**Proposed Private Plan Change – Campana Road
Clause 23 Request for Further Information Response (Transport)**

**Proposed Private Plan Change – Campana Road
Additional Clause 23 Request for Further Information Response (Transport)**

**Proposed Private Plan Change – Campana Road
Clause 23 Request for Further Information Response (Transport)**

**Proposed Private Plan Change – Campana Road
Clause 23 Request for Further Information Response (Transport)**

Figure 1: Campana / Puhinui intersection – Indicative Upgrading Option 1

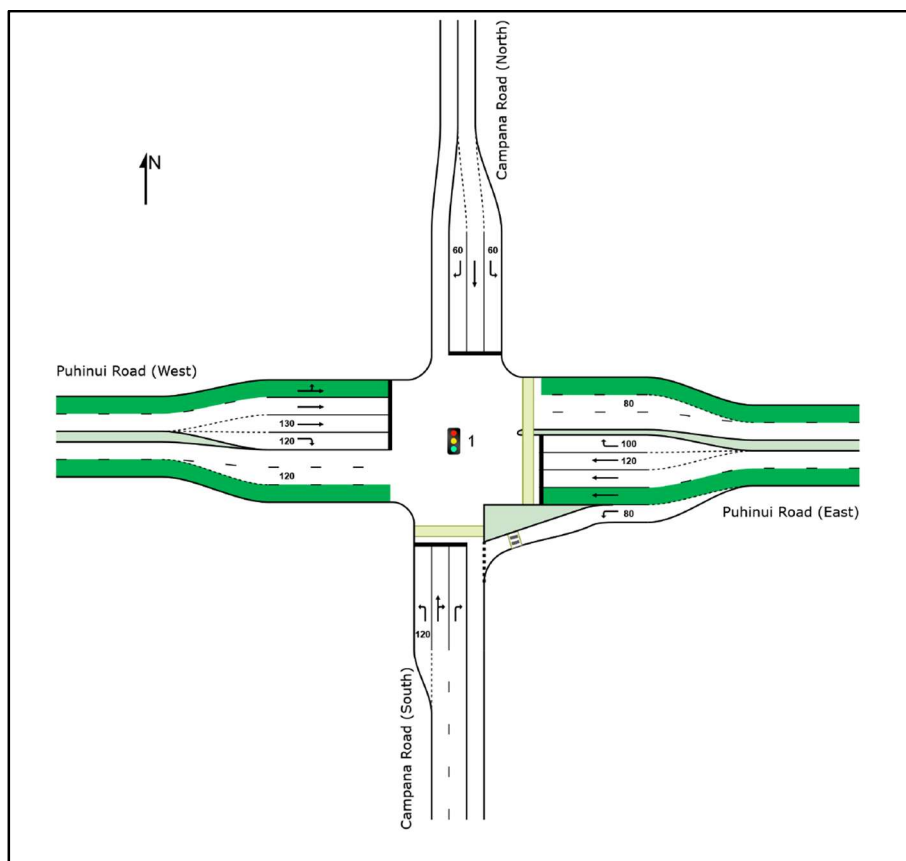
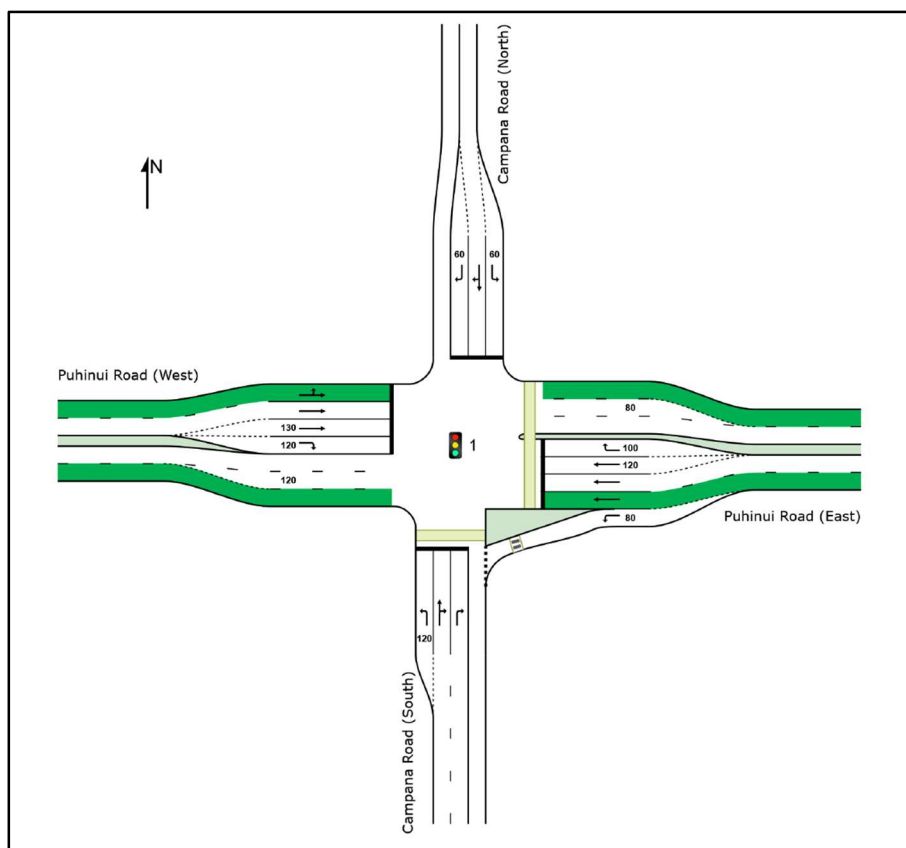
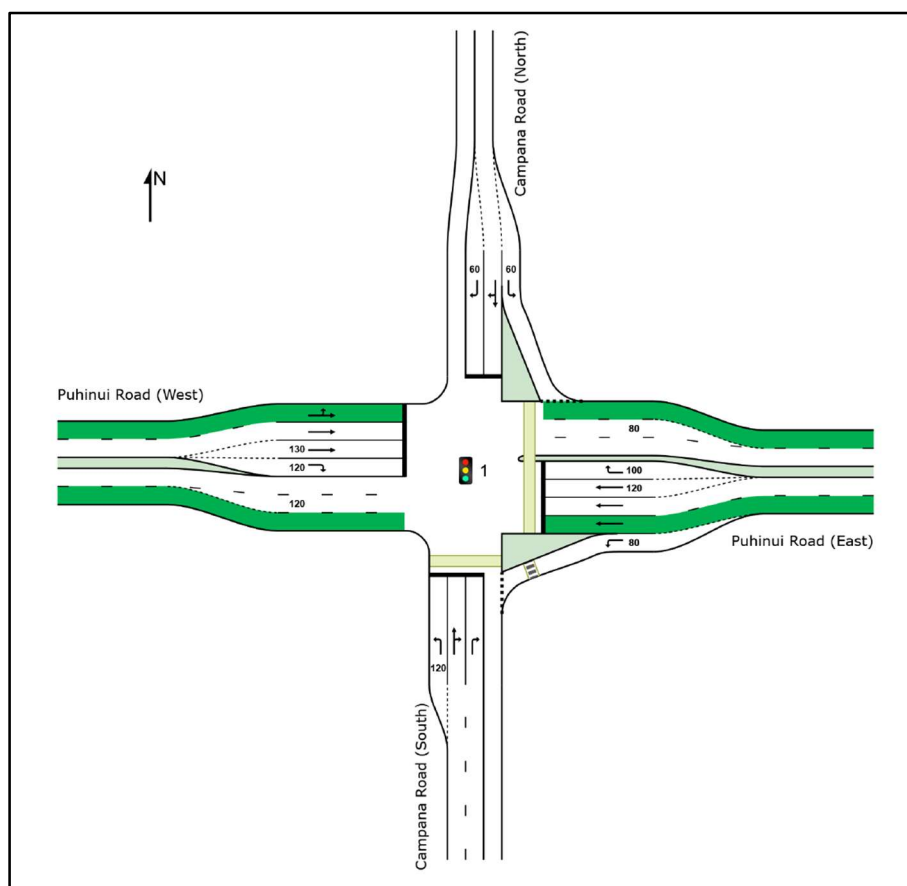
Please provide an indicative intersection layout design with additional capacity to alleviate Levels of Service E/F recorded at this intersection.

The SIDRA analyses presented in the Third RFI Response (Feb 2025) included diagrammatic representations of the widening options considered and modelled to address the future performance and operation of the intersection under future development demands. A copy of each of these is shown below for ease of reference.

The above figures indicates that each of the upgrading/widening options of the Campana Road approach involve achieving generally a total of four traffic lanes for approximately 60m back from the Puhinui Road signals. As confirmed in the Third RFI Response, the current road reserve with for Campana Road is 20m which can at a concept design level accommodate the width of four traffic lanes (especially reflecting the typical width of turning/queuing lane at an intersection such as this may not necessarily need to be a mid-block lane width).
